ORDER NO. MD0512458S3

Service Manual

SA-AK331GCP

Top Cabinet change (Additional Information)

2.1. Cabinet Parts Location (Additional Information)

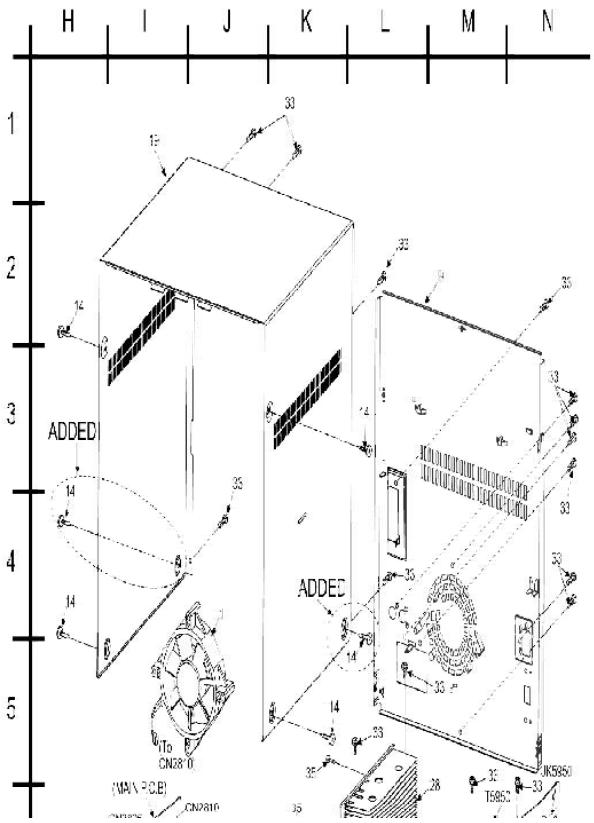
During the replacement of the top cabinet for the mentioned models, the below rules of compatibility (Table 1) must be followed & parts must be replaced correctly. This is mainly due to top cabinet specification change (additional of one screw hole) for improvements.

- When replacing the new top cabinet, ensure that the NEW bottom

chassis must also be changed together at the same time (Refer to Table 1).

- Do not interchange the parts.

With reference to page 95 (section 23.3.1) of the original service manual for SA-AK331GCP-S. The cabinet parts location below is for the new implementation.

With reference to page 96 (section 23.3.2) of the original service manual for SA-AK331GCP-S. The parts list below is for the new implementation.

Ref. No.	Part No.	Part Name & Description	Remarks
		CABINET AND CHASSIS	
19	RKMX0105-S1	TOP CABINET	[M]
22	RMKX0099-2	BOTTOM CHASSIS	[M]
